ROUTINE SANITARY SURVEY REPORT

June 8, 2018

DOCKTON WATER ASSOCIATION

ID # 19550J, King County

Figure 6. Dockton Springs booster station with variable frequency drives.

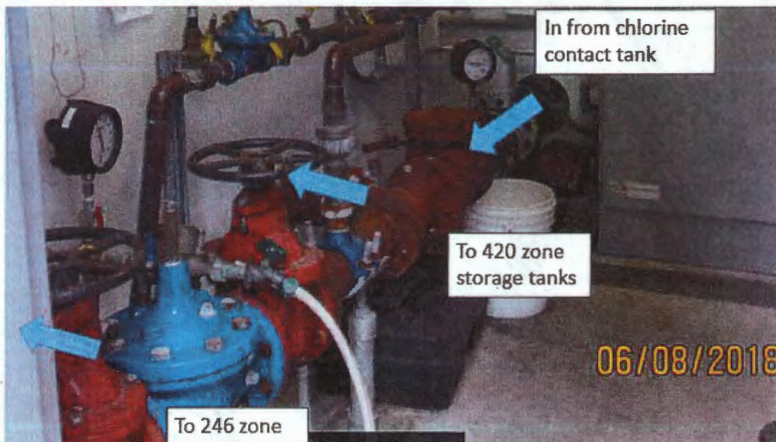
They measure flow rate and chlorine residual at entry point to distribution from the Dockton Springs booster station (Figure 6). For a maximum flow rate of 143 gpm, the minimum chlorine residual at entry point must be 0.55 mg/L for CT6. Monthly reports indicate they consistently meet the CT6 requirement.

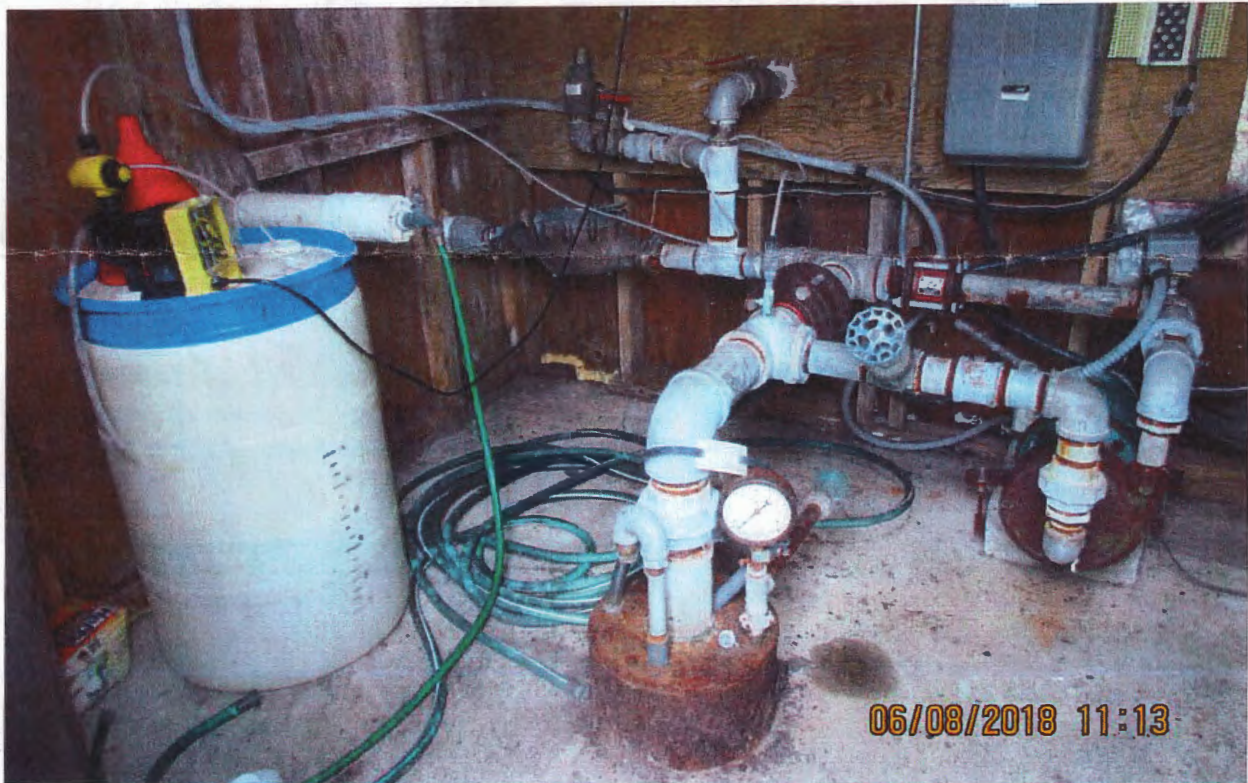
The Sandy Shores Well is used seasonally to meet peak demand (Figure 7). Manganese and iron exceed the secondary maximum contaminant levels (MCLs) (aesthetic concern). All primary MCLs (health concerns) are in compliance. The Association plans to rebuild the well house and install treatment for iron and manganese removal. WTPO1 certification will be required upon completion of the treatment plant.

Figure 7. Sandy Shores well, 100gpm Qi, and sodium hypochlorite disinfection treatment. Make up water for the hypochlorite solution fed by the hose. LMI feed pump. They keep a spare LMI feed pump and parts at the office. The sanitary control area is in good condition. Good seals and screens. The discharge line that goes out through the back wall serves as a raw source water tap. Propane back up power generator on site.
